Access Compliance Report

Public Rights-of-Way

(Curb Ramps)

Intersection ID: 30086	Main Street: DEVONBRIDGE_LN	Cross Street: DEVONGATE_LN	Location: S
ADA ID: 56C672180060	Ramp Type: PerpDiag	Initial Pass/Fail: Fail	Overall Compliance: No
Severity Score: 33.75			
Codes/Mitigation Info/Possible Solution		Field Measurements/Component Compliance

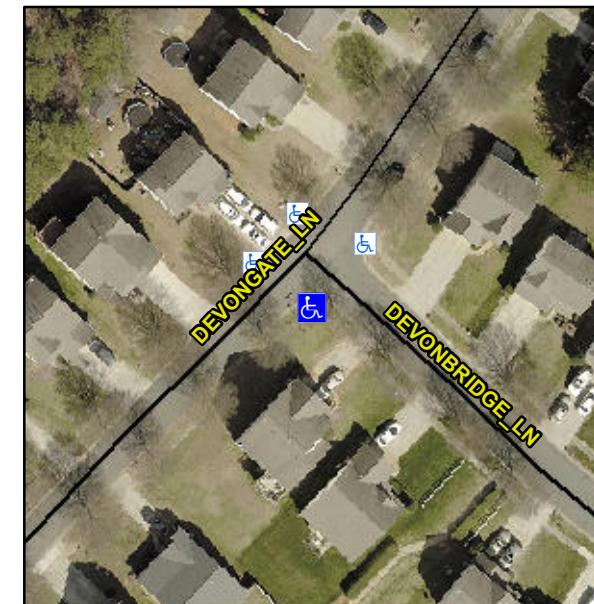
Not Found, R304.5.1, R304.2.2

Compliance	Description	Data	Compliance	Description	Data
N/A	Ramp Length (in)	51.0	No	Ramp Slope (%)	20.0
No	Ramp Width (in)	42.0	Yes	Ramp XSlope (%)	0.6
N/A	Flare Type LT	N/A	N/A	Flare Type RT	N/A
N/A	Flare Slope LT (%)	N/A	N/A	Flare Slope RT (%)	N/A
N/A	Flare Traversable LT?	N/A	N/A	Flare Traversable RT?	N/A
N/A	Landing Length (in)	N/A	N/A	DWS Provided?	N/A
N/A	Landing Width (in)	N/A	N/A	DWS Contrast?	N/A
N/A	Landing Slope (%)	N/A	N/A	DWS Length (in)	N/A
N/A	Landing X Slope (%)	N/A	N/A	DWS Full Width?	N/A
N/A	Landing Curb? (Y/N)	N/A	N/A	DWS Offset (in)	N/A
N/A	Shared Landing?	N/A			
N/A	Gutter Ponding?	N/A	N/A	Gutter Slope (%)	N/A
N/A	Gutter Lip Ht (in)	N/A	N/A	Gutter X Slope (%)	N/A
N/A	Painted X Walk1?	No	N/A	Painted X Walk2?	No
	X Walk 1 Direction	To NE		X Walk 2 Direction	To NW
N/A	X Walk 1 Width (in)	N/A	N/A	X Walk 2 Width (in)	N/A
	X Walk 1 Slope (%)	0.1		X Walk 2 Slope (%)	0.4
	X Walk 1 X Slope (%)	2.2		X Walk 2 X Slope (%)	6.1

Remove & Replace Curb Ramp With Two New Directional Ramps or Equivalent.
